Application for Planning Permission for Proposed Temporary Warehouse for Storage of Construction Materials and Electronic Products and Associated Filling of Land for a Period of 3 Years at Lots 4 S.A(Part), 4 S.B(Part), 4 S.C(Part) and 6 S.B(Part) in D.D. 84, Ping Che, N.T.

(Application No. A/NE-TKL/852)

Table 1: Responses to Departmental Comments (Application No. A/NE-TKL/852) (8 October, 2026)

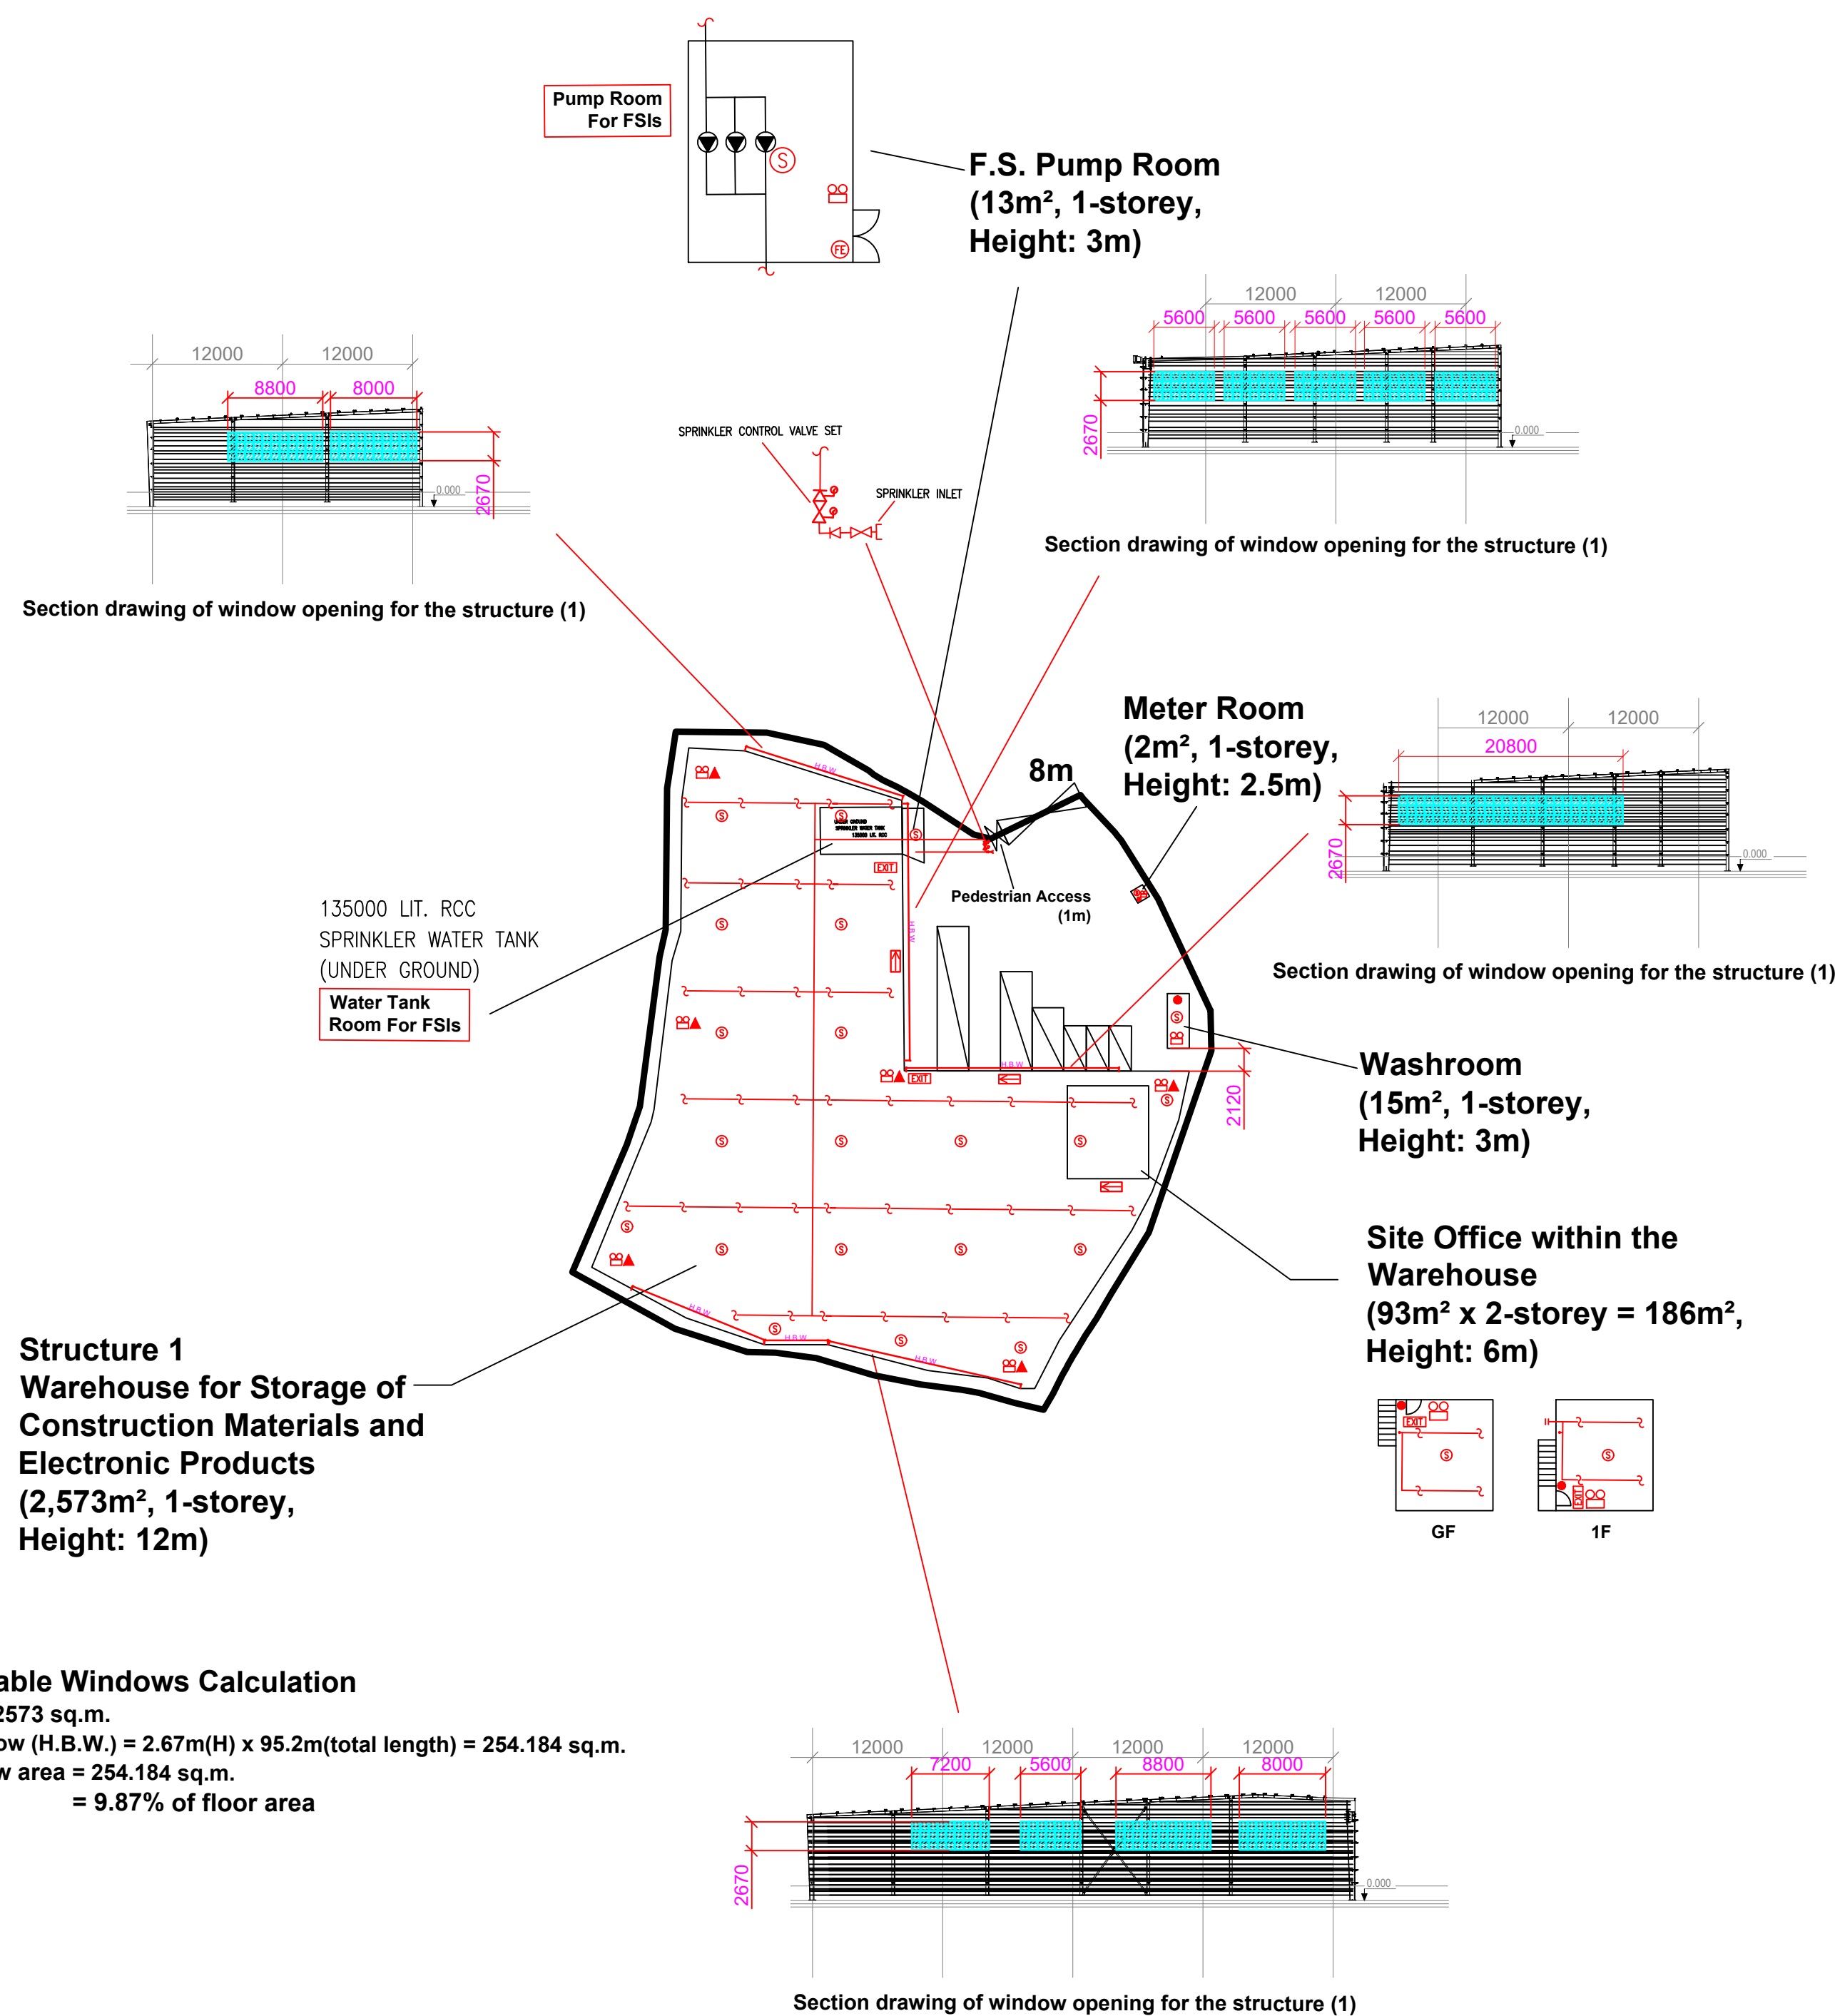
2.	Fire Services Department	
(i)	based on the submitted fire service installations proposal, FSD has the following comments: the sprinkler inlet and sprinkler control valve shall be provided at prominent location (i.e. at external wall as close as practical to the entrance) and clearly indicated on the plans;	The sprinkler inlet and sprinkler control valve will be provided near the site entrance (see the revised FSIs Proposal in Annex 4).
(ii)	the height of each section of openable windows shall be provided;	The height of each section of openable windows has been provided.
(iii)	licensing requirements, if any, would be formulated upon receipt of formal application via the Licensing Authority; and	Noted.
(iv)	the application involves substantial structural works which may be subject to the Buildings Ordinance (Cap. 123). The applicant should consult the Building Authority to ascertain whether the provision applies.	Noted.
